Explanation of Significant Differences

Upper and Lower Harbor Operable Unit

New Bedford Harbor Superfund Site

September 2001

Figure 2
 Updated Dermal Risk Areas
 New Bedford Harbor Superfund Site

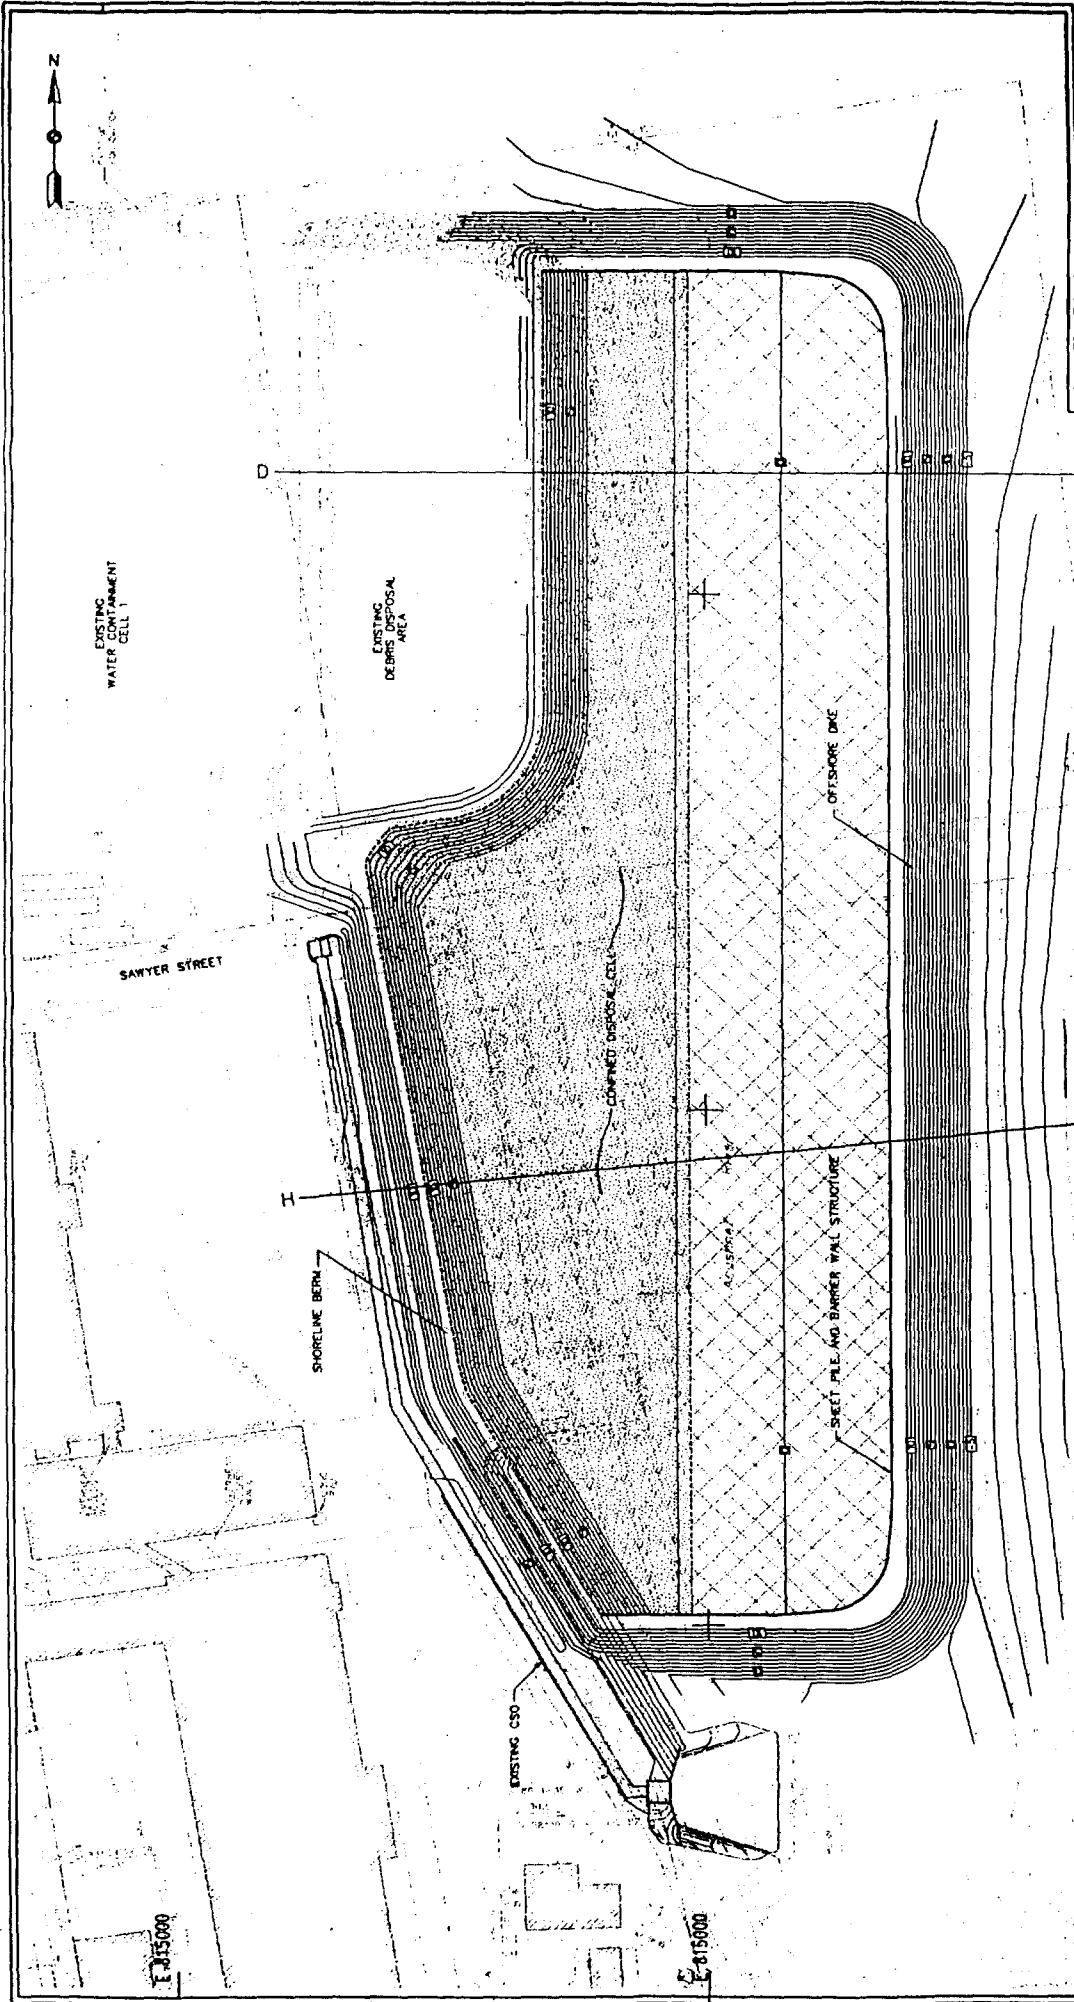
In addition to these three areas, EPA is now aware, based on post-ROD sampling, of at least two other areas in the upper harbor where these intertidal, dermal-based cleanup levels are appropriate to protect human health. These two areas are the small residential area along the Acushnet River just south of Main Street in Acushnet, and the area slated for "River Road Park" directly across the river along River Road in New Bedford. See Figure 2 attached.

Figure 3a
 NEW BEDFORD HARBOR SUPERFUND SITE
 NEW BEDFORD, MASSACHUSETTS
**CONFINED DISPOSAL
 FACILITY C PLAN**

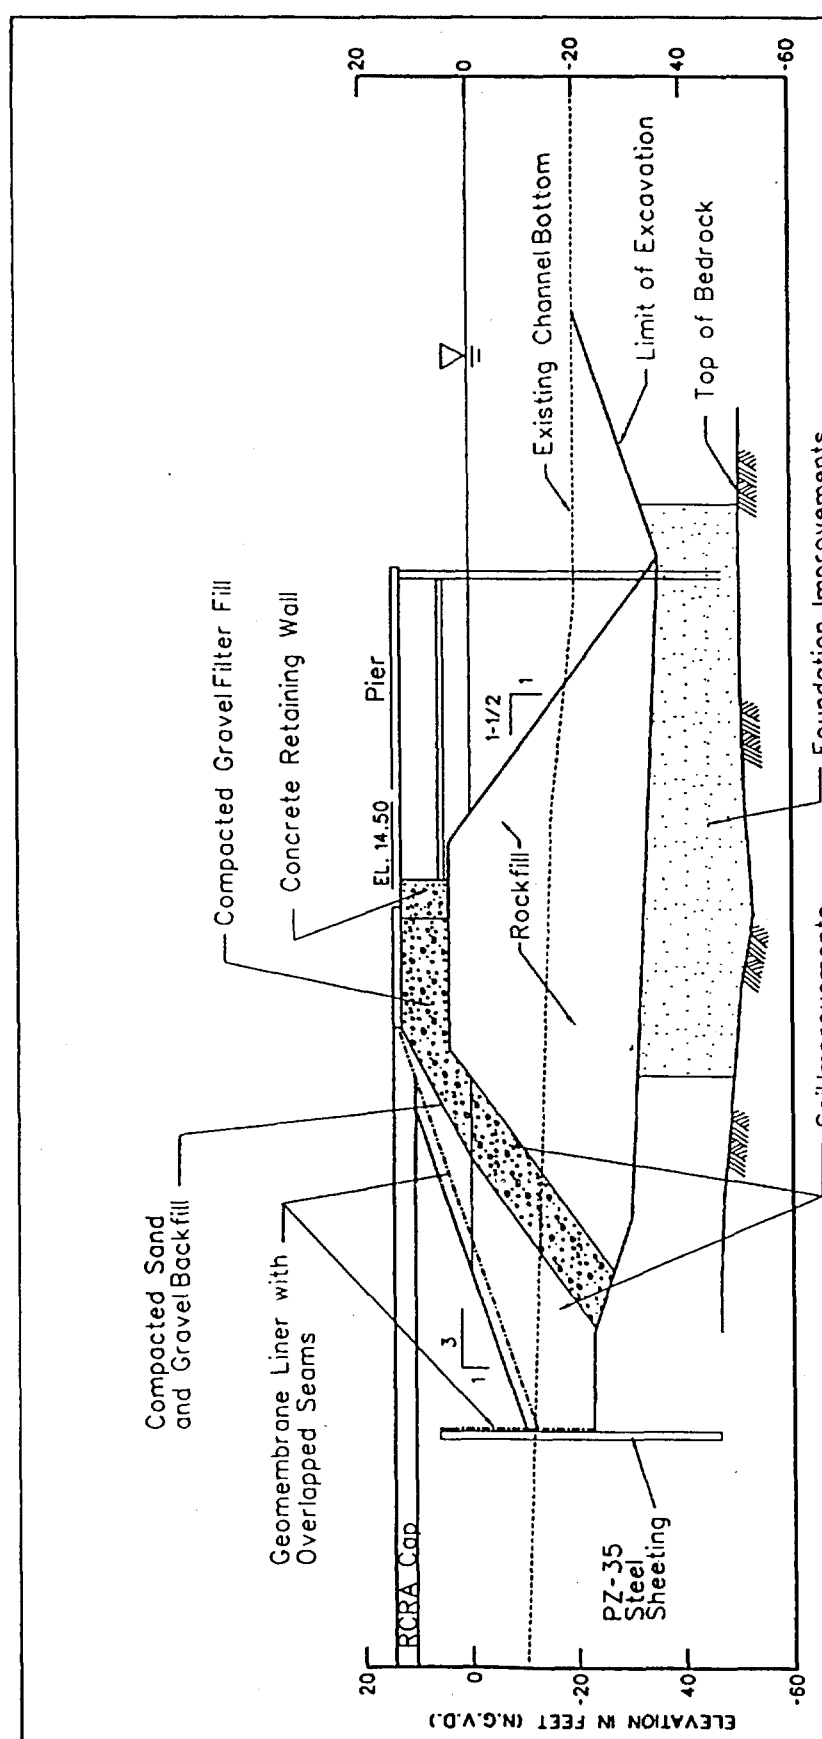
Groundwater and air monitoring have been and continue to be performed in and around the DDA, all of which indicates that PCBs are not migrating from the DDA (USEPA, 2001a, USEPA, 2001b). In addition, testing of the current surface layer of the DDA shows that it does not present an unreasonable dermal exposure risk (USACE, 2001). With regard to the soil conditions underlying the DDA, Figures 3.a and 3.b attached show the most recent cross-section

of this area, taken from the CDF C design. This cross section shows a clay layer sandwiched between the DDA and the underlying sands of the area. In addition, test pit logs from the pilot study report indicate a concrete slab approximately four to six feet below the 1987 ground level in much of the western portion of the DDA (USACE, 1990).

Given these groundwater, surface soil and air monitoring results, the subsurface features in the area and the fact that the dredged sediments in the DDA are naturally very impermeable, EPA will continue to use this DDA area as an interim TSCA facility for PCB-contaminated sediment from the site. This facility must comply with TSCA regulations governing remediation waste. CERCLA § 121. Section 761.61(c) of the TSCA regulations require that the EPA Regional Administrator make a determination that the facility does not pose an unreasonable risk to health or the environment. After reviewing the information contained in the administrative record, the Regional Administrator, by his signature on this document, determines that the facility does not pose an unreasonable risk to health or the environment as long as the following conditions are maintained: (1) Groundwater and air monitoring of this area is continued as long as the PCB contaminated sediment remains in place; (2) subsurface conditions remain intact; (3) surface PCB levels in the DDA remain low or, alternatively, a clean soil cover (approximately six inches thick) is placed so that it does not pose an unreasonable risk to health or the environment and (4) a final resolution of the facility is made in a later decision document.

ENVIRONMENTAL PROTECTION AGENCY
 NEW BEDFORD HARBOR SUPERFUND SITE
 NEW BEDFORD, MASSACHUSETTS
 CONFINED DISPOSAL FACILITY "D"

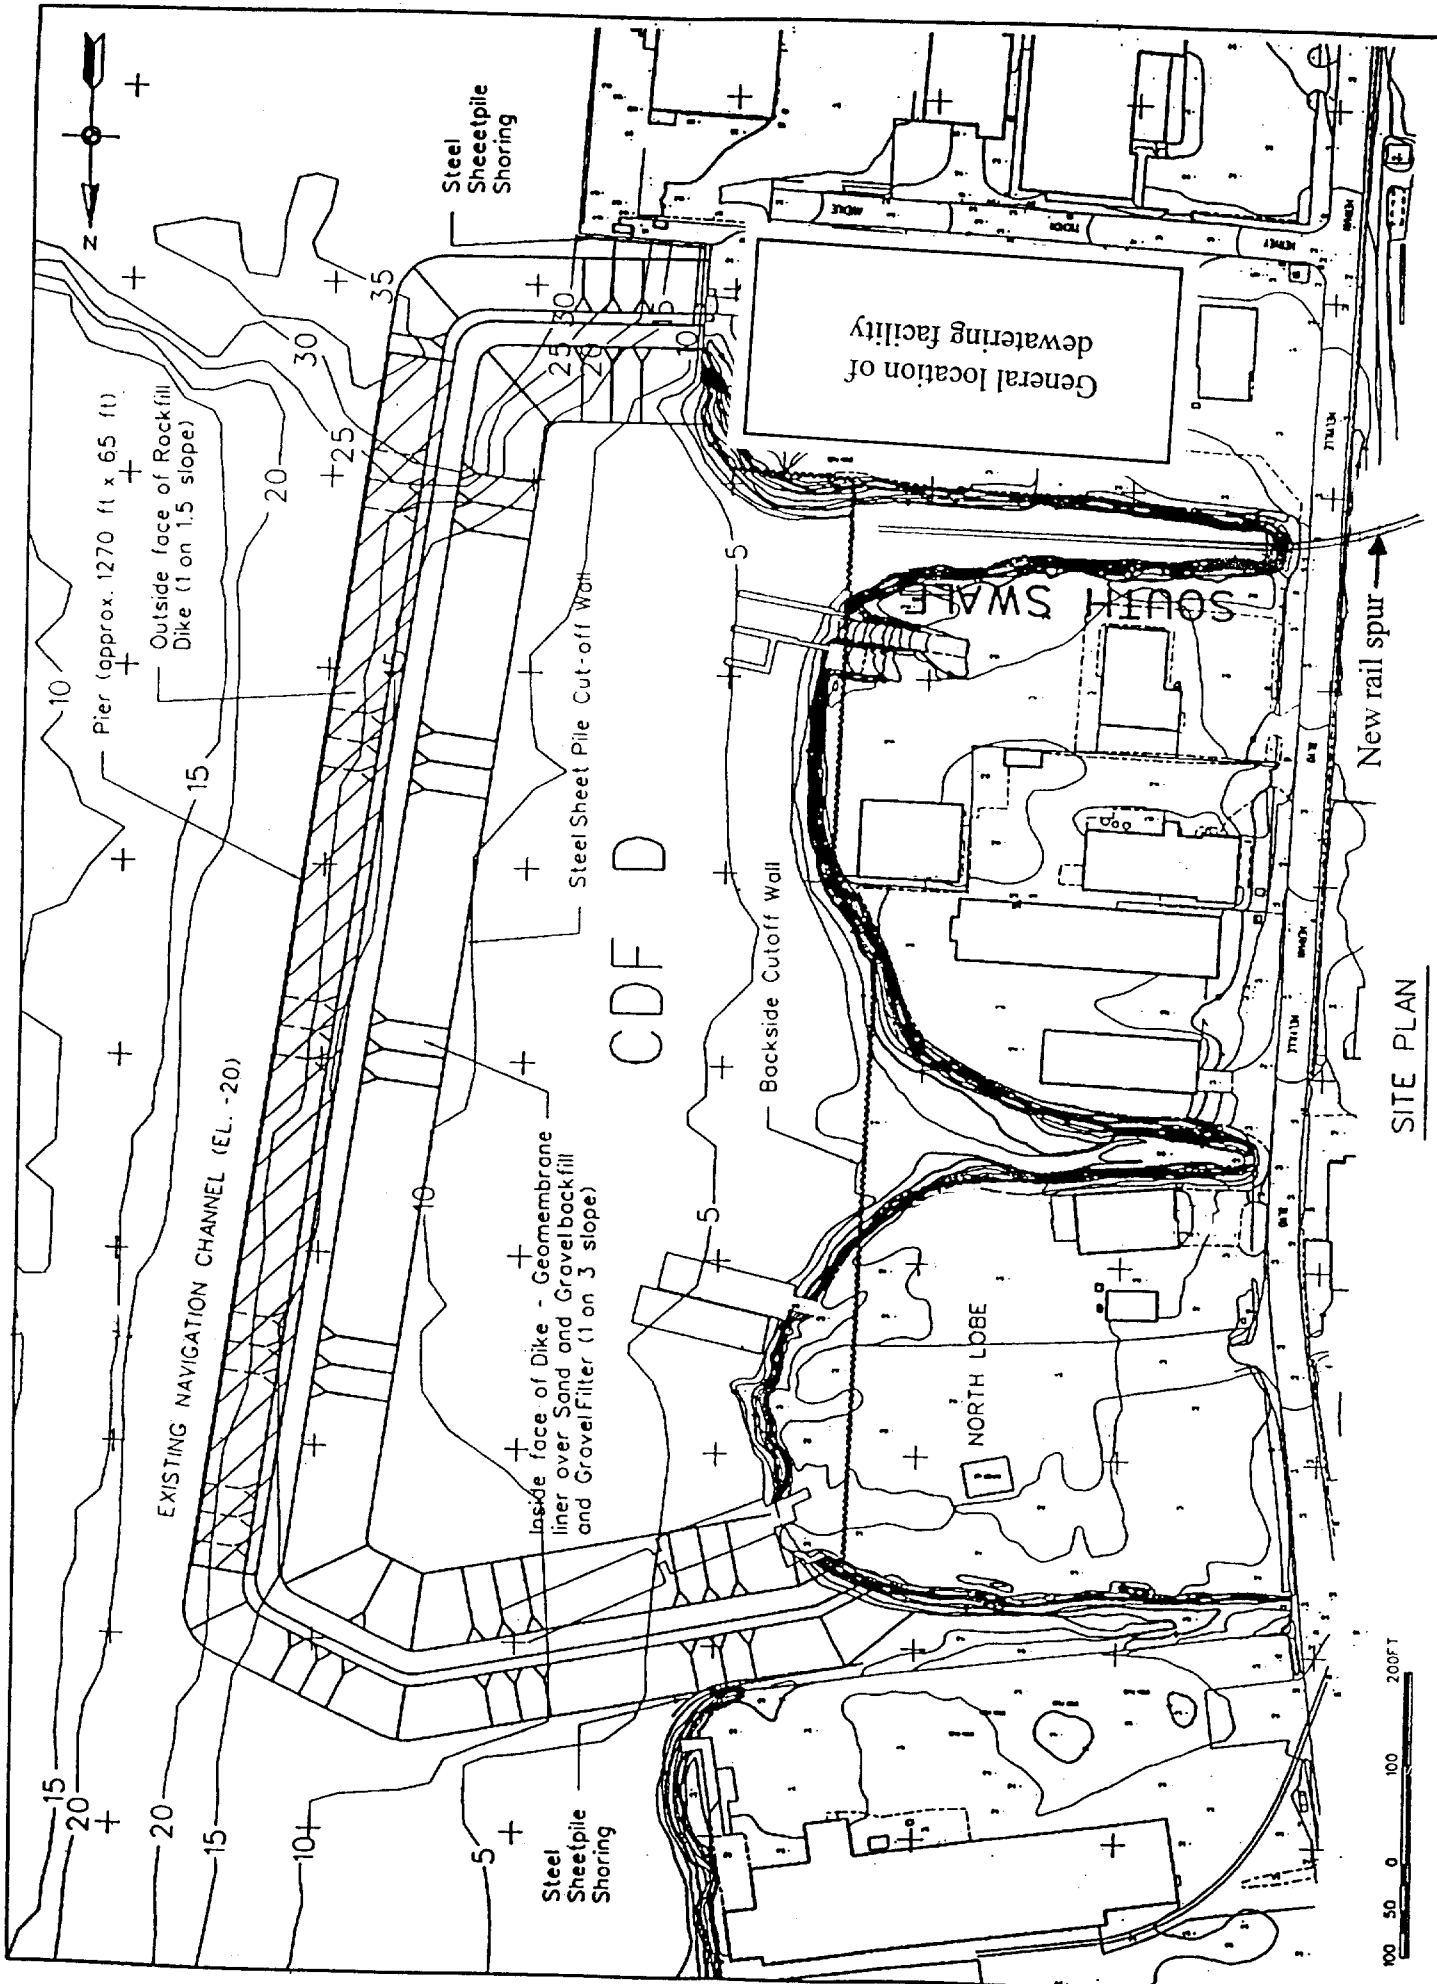
considered insignificant (see p.29 of the 1998 ROD); d) it produces a sediment "cake" which can be placed mechanically and which is dryer than the slurry from hydraulic dredging, thereby decreasing the time required for consolidation and temporary capping of sediment placed in the CDFs; and e) it allows the earlier application of heavier loads during beneficial reuse of the final CDFs. The conceptual location of the dewatering facility is shown in Figure 5 attached.

In addition, due to the inclusion of mechanical dewatering discussed above and the volume reductions it allows, the overall footprint of CDF D has been reduced from that conceived in the 1998 ROD. Figure 5 attached shows the revised footprint with the rock filled dike design. This reduction has eliminated the need to relocate the navigational channel in this area, which would have been covered by the original CDF D footprint.

As discussed in Section II.D, the current CDF wall design requires substantially more construction material than the ROD's conceptual sheet pile wall design, and the 300,000 cy of "foundation" sediments would likely need to be transported offsite. Use of rail for this material delivery and offsite transport would thus help alleviate community concerns about increased truck traffic during the remedy. Addition of a rail spur also aligns with the City of New Bedford and Harbor Development Commission's long term plans for a multi-modal port facility for the CDF D area, as developed in their recent harbor master plan (New Bedford, 2001; VHB, 2000). The conceptual location of this rail spur is shown in Figure 5 attached.
